OHIO TURNPIKE COMMISSION

ADDENDUM NO. 3

CONTRACT NO. 43-13-03

BRIDGE DECK REPAIR AND REHABILITATION  
RAMP OVER TURNPIKE M.P. 161.5,  
RAMP OVER TURNPIKE M.P. 161.8,  
RAMP OVER TURNPIKE M.P. 173.2,  
CUYAHOGA AND SUMMIT COUNTIES, OHIO

NO.	ADDENDUM 3	CAC	5/13
	REVISIONS	BY	DATE
<b>OHIO TURNPIKE COMMISSION</b>			
<b>MAINTENANCE OF TRAFFIC PHASE 1</b>			
<b>MP 161.8-RAMP OVER OHIO TURNPIKE</b>			
DATE:	APRIL 30, 2013	SCALE:	NOT TO SCALE
CONTRACT NO.	43-13-03	SHEET	5/19

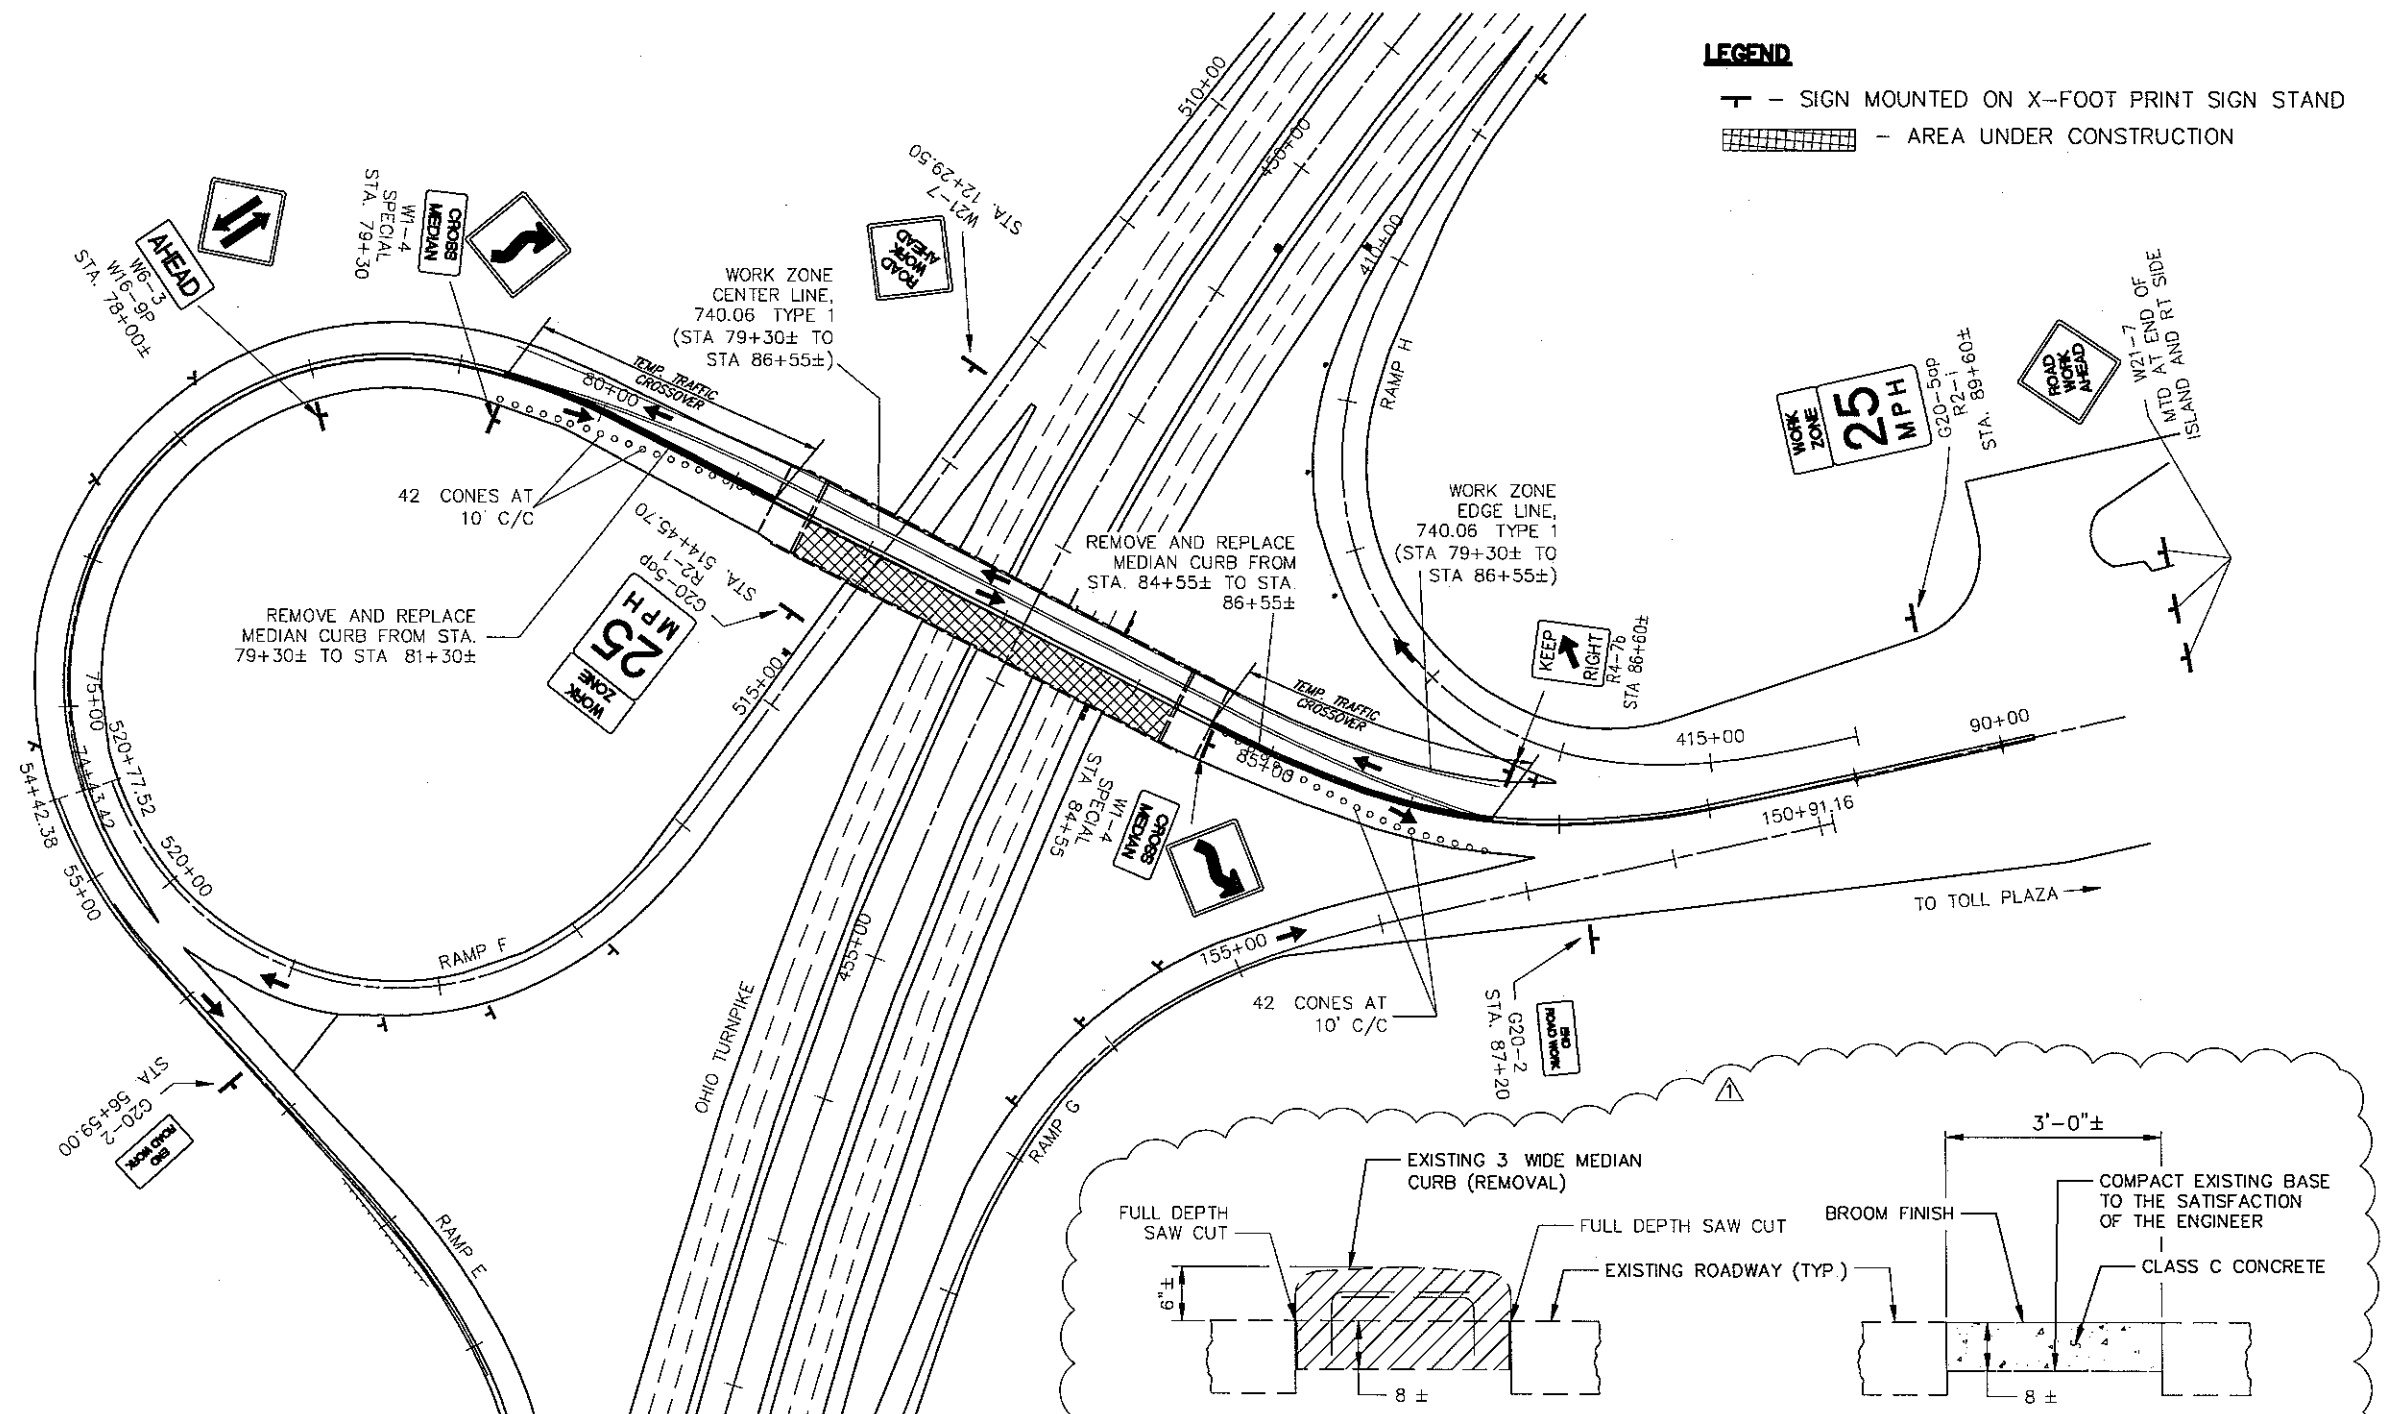
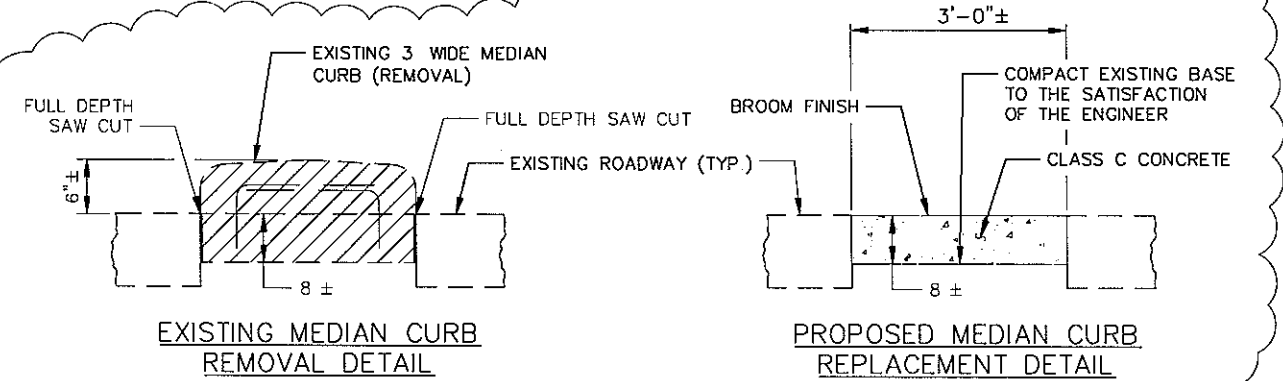
**Q#5** Plan notes on sheet 5/19 and 7/19 indicate removal of the existing median incidental to SP614 Maintaining Traffic. Can the OTC provide a detail of the existing/proposed median that shows any rebar and/or doweling required and the lineal feet of removal/replacement required per location?

**Q#6 Regarding [Q#5] we found the lineal foot of removal required but would appreciate any as built/existing details available.**

**Plan Sheet 5 of 19**

Two (2) new Details were added as "***Existing Median Curb Removal Detail***" and "***Proposed Median Curb Replacement Detail***."

The Note for "Removal and Replacement of Concrete Median" was modified as follows:

A#5 *Median Curb Removal and Replacement Details have been added via this Addendum No. 3 on Plan Sheet 5 of 19. A Plan Note has been added via this Addendum No. 3 on Plan Sheet 7 of 19 which references the Details added on Plan Sheet 5 of 19.*

**EXISTING MEDIAN CURB  
REMOVAL DETAIL**

**PROPOSED MEDIAN CURB  
REPLACEMENT DETAIL**

ADDENDUM 3		CAC	5/13
NO.	REVISIONS	BY	DATE
<b>OHIO TURNPIKE COMMISSION</b>			
<b>MAINTENANCE OF TRAFFIC PHASE 1</b>			
<b>MP 173.2-RAMP OVER OHIO TURNPIKE</b>			
DATE: APRIL 30, 2013		SCALE: NOT TO SCALE	
CONTRACT NO. 43-13-03		SHEET 7/19

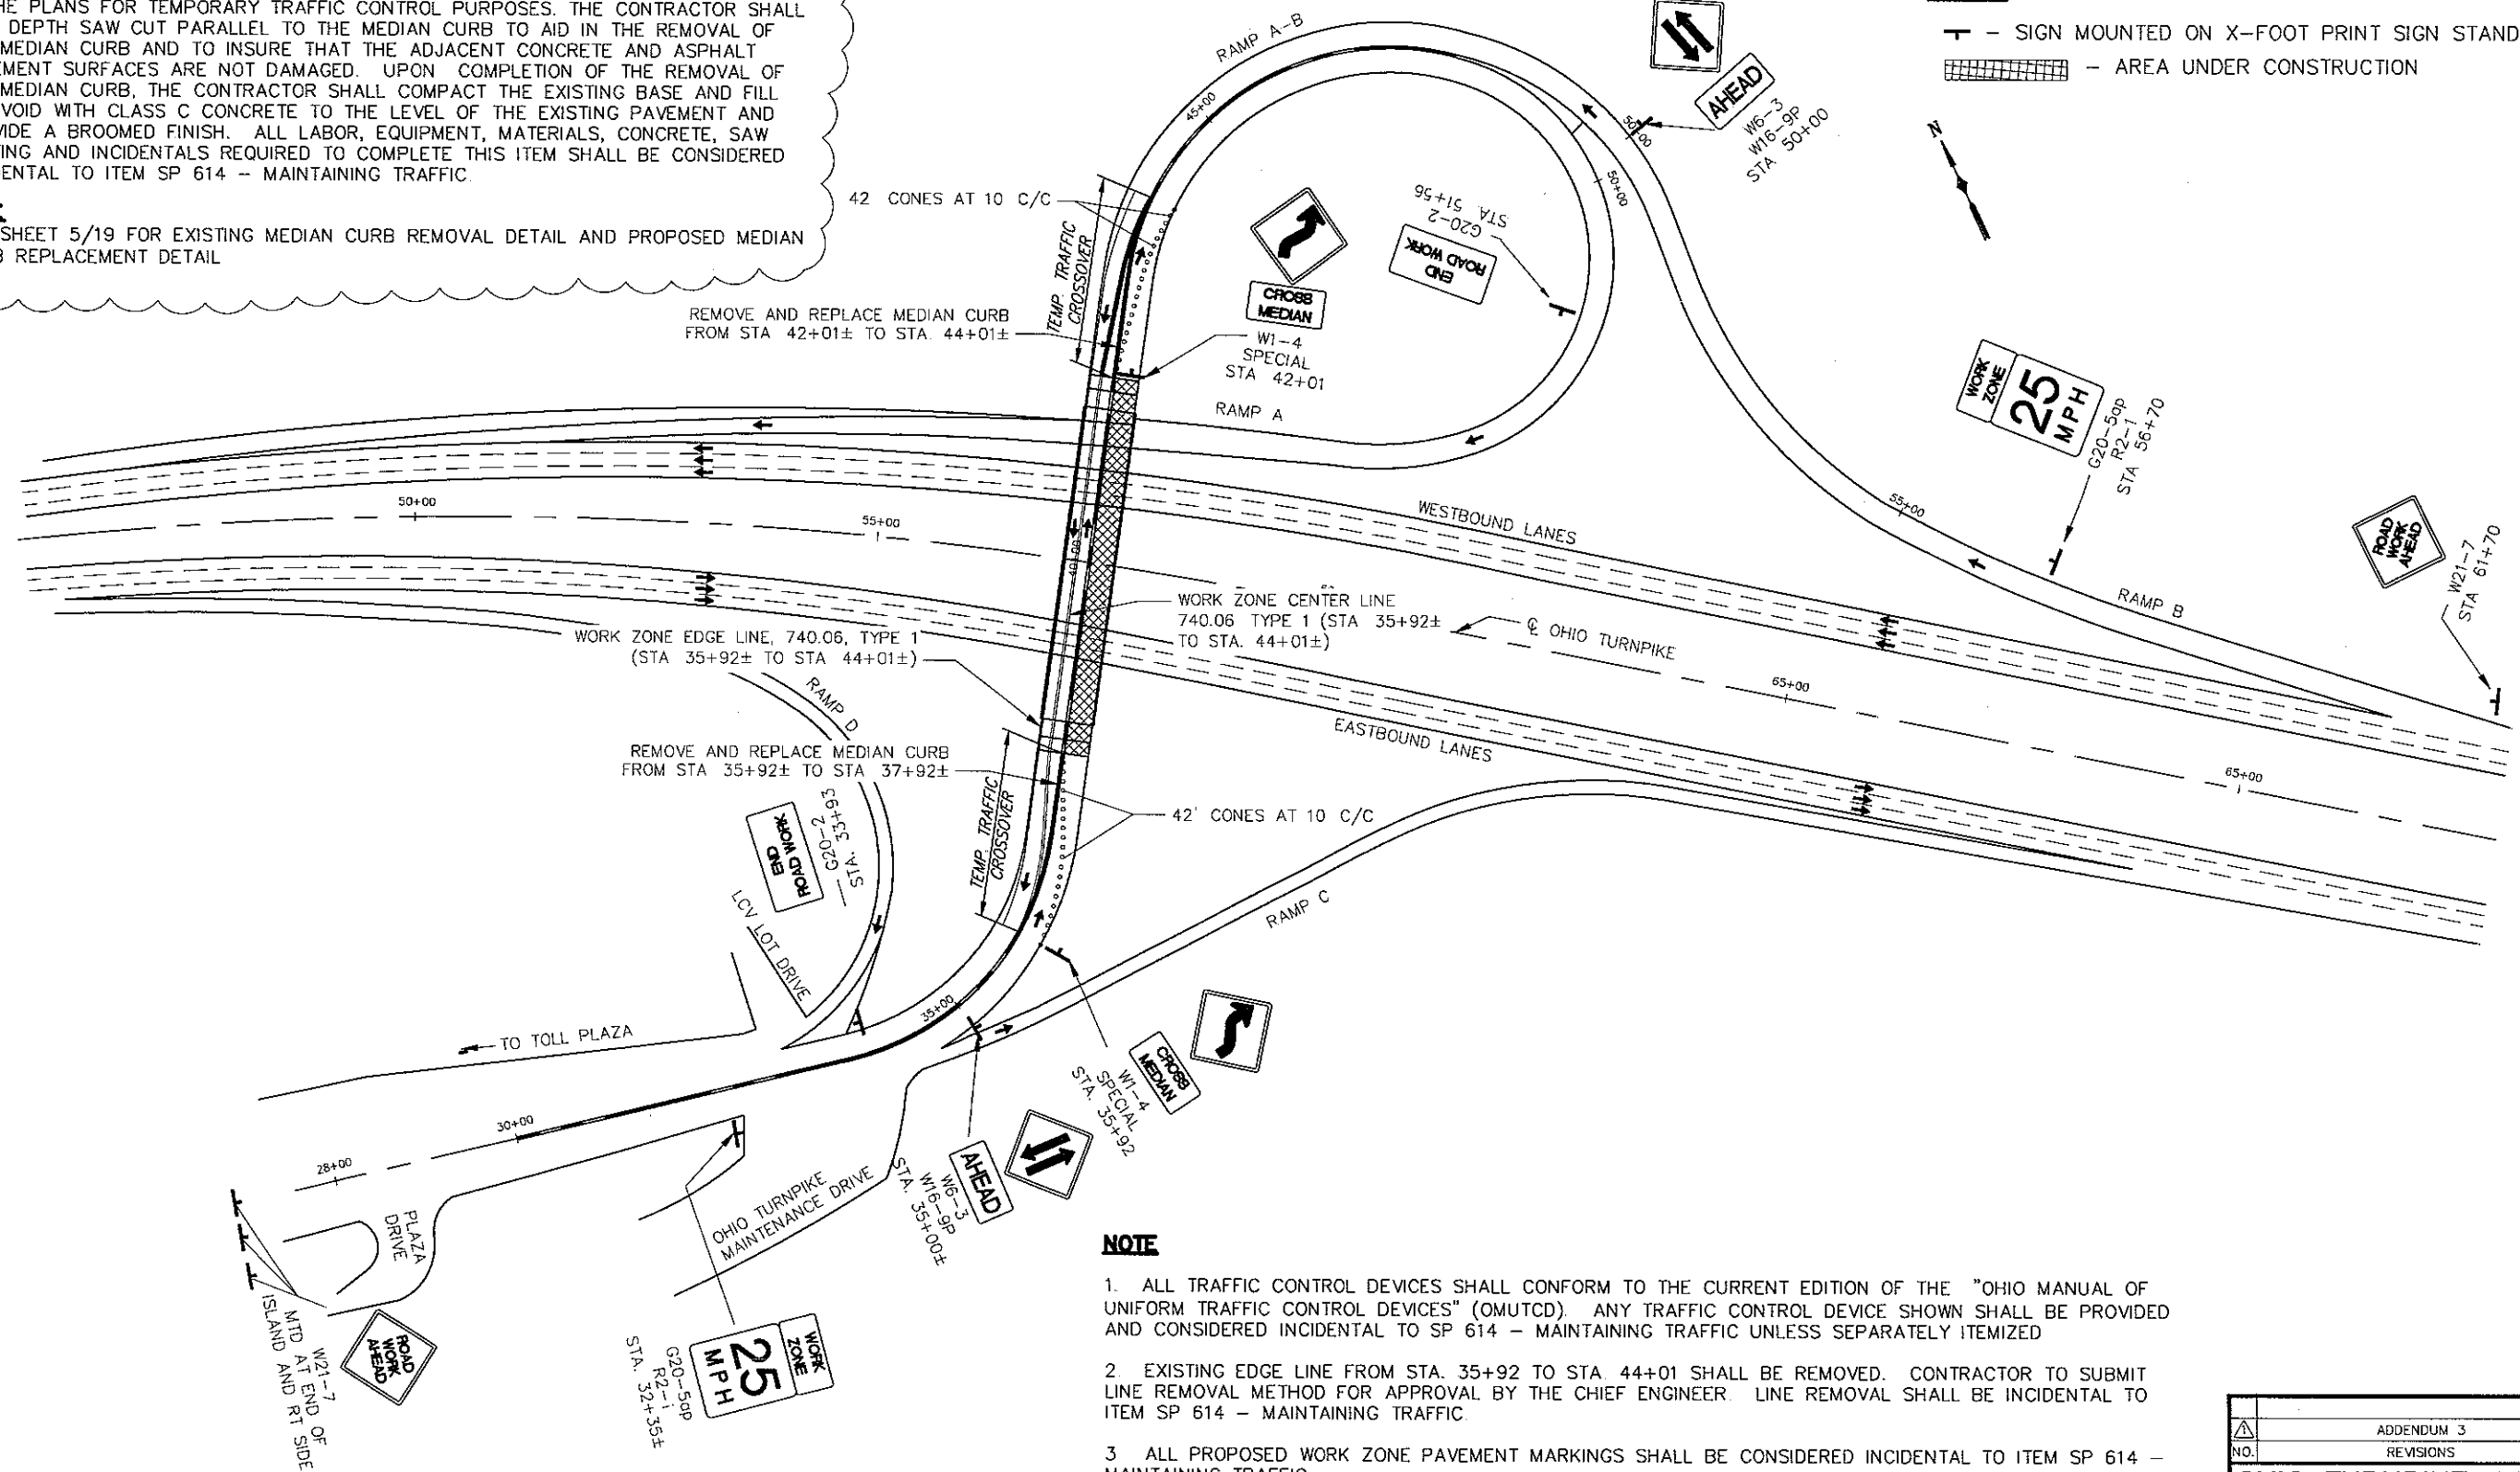
**Plan Sheet 7 of 19**

The Note for "Removal and Replacement of Concrete Median" is modified as follows:

A new **NOTE** is added that states as follows:

**"SEE SHEET 5/19 FOR EXISTING MEDIAN CURB REMOVAL DETAIL AND PROPOSED MEDIAN CURB REPLACEMENT DETAIL."**

SEE SHEET 5/19 FOR EXISTING MEDIAN CURB REMOVAL DETAIL AND PROPOSED MEDIAN CURB REPLACEMENT DETAIL
